Airport Moving Map Alert

Subject: Oostende, Belgium
Oostende-Brugge (EBOS)
Cycle 2606

Apron 3 layout incorrect. TWYs aircraft restrictions incorrect.

EBOS_2606

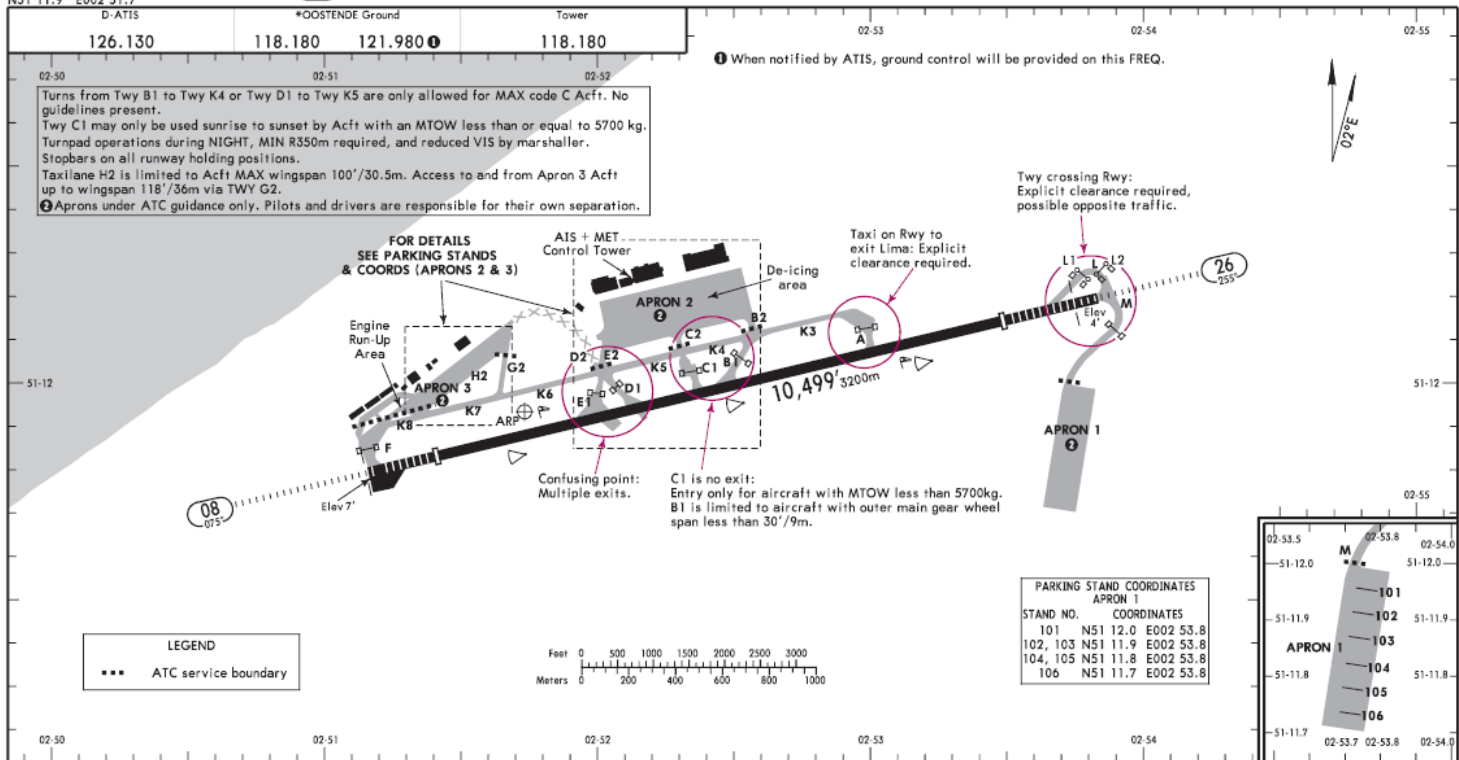
CHANGES: Hot spot description, note.

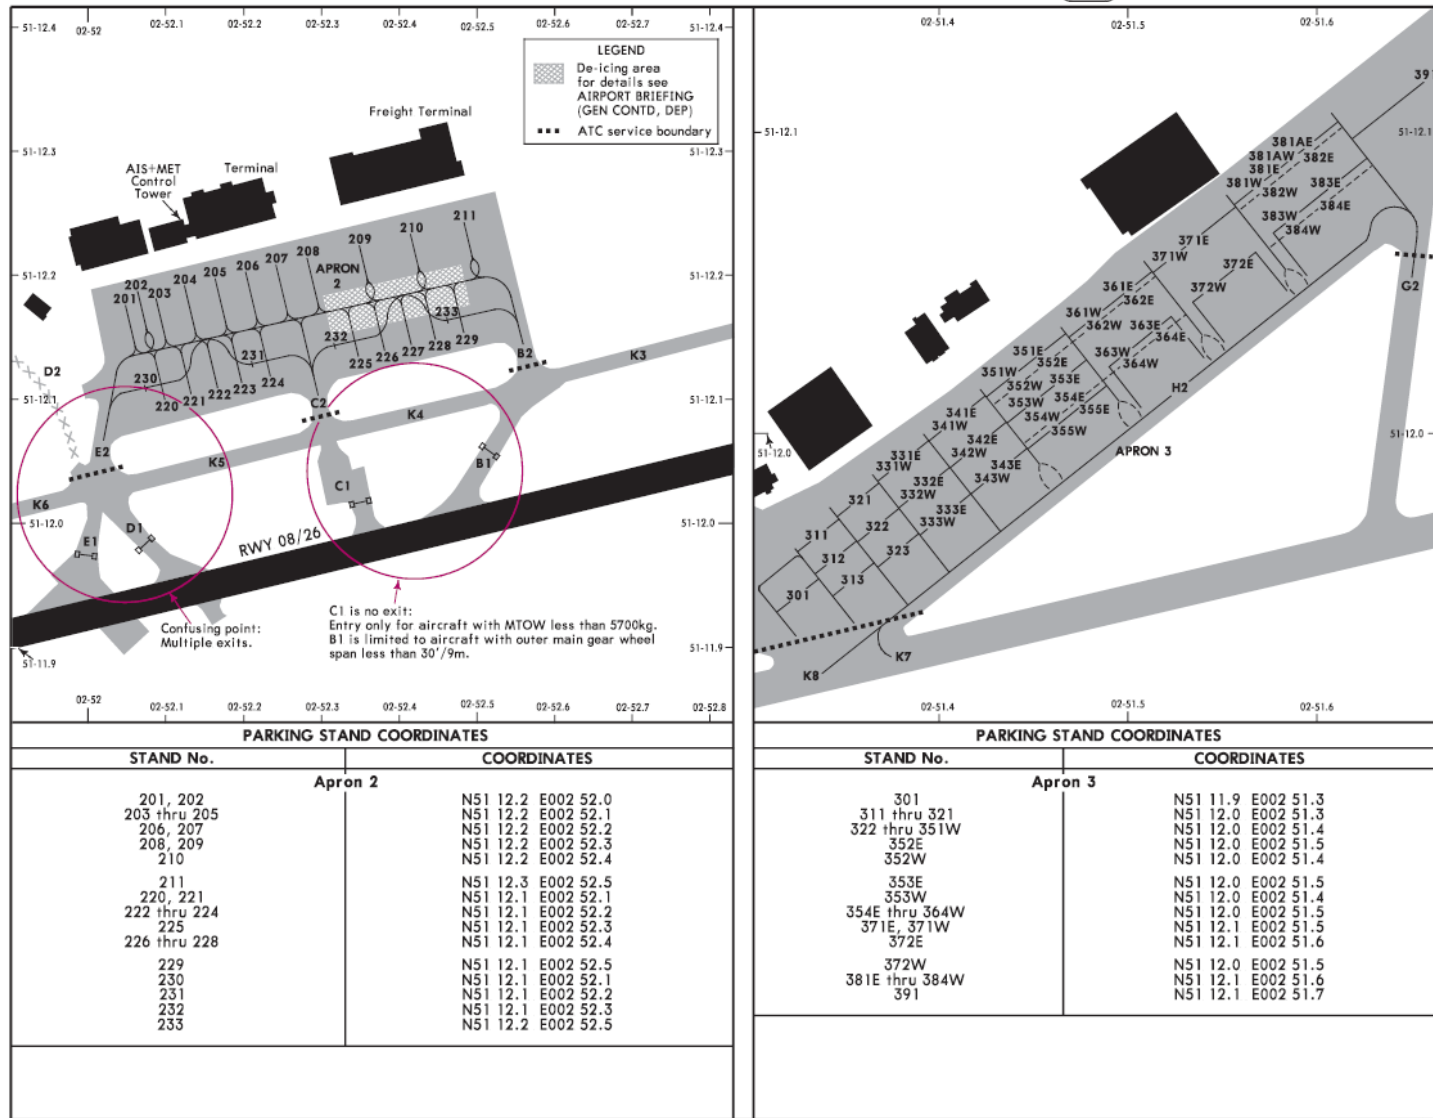
CHANGES: Apron 3 parking.

- Parking Stands 1E-16W (on Apron 3) are removed
- Parking Stands 301-391 (on Apron 3) are added
- TWYs B1, B2, C1, G2, H2 aircraft restrictions are updated
- Hot Spot description is updated
